ADDENDUM No. THREE

Date: October 26, 2011

Project Name: Austin Energy Town Lake Center, 5th Floor Office Renovations

IFB No. CLMC 335

ADDENDUM No. 3
 Revised Reflected Ceiling Plan 1/A7

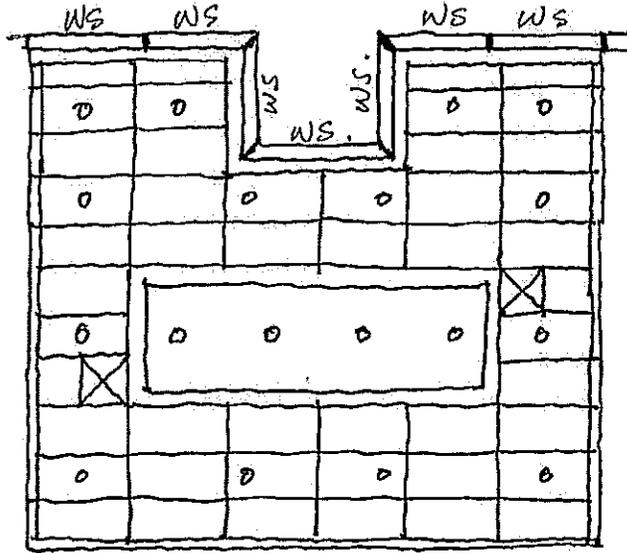
1. On Drawing Sheet A1, at Board Room 501, add note to read: "Contractor shall remove 7 existing mini-blinds located on exterior windows and in its place install new Manual Roller Shades as specified". And add second note to read: "Contractor shall remove existing mini-blinds located on entry glass wall, patch holes in wood frame and refinish as noted on 8/A5.
2. On Drawing Sheet A5, revise Notes on 2 Board Room 501 - North and 3 Board Room 501 - West to read: "Manual Roller Shades as specified to be inside jamb surface mounted on existing window frames, 7 roller shades total". Refer to Addendum No. 2 Sheet AD-A7 that is part of this Addendum.
3. On Drawing Sheet A7, Reflected Ceiling Plan, add notes to Board Room 501 as shown on attached drawing AD-A7 that is part of this Addendum.

7 SECTIONS OF
 WS = SURFACE MOUNTED INSIDE
 JAMB INSTALLATION OF ROLLER
 SHADES AS SPECIFIED.
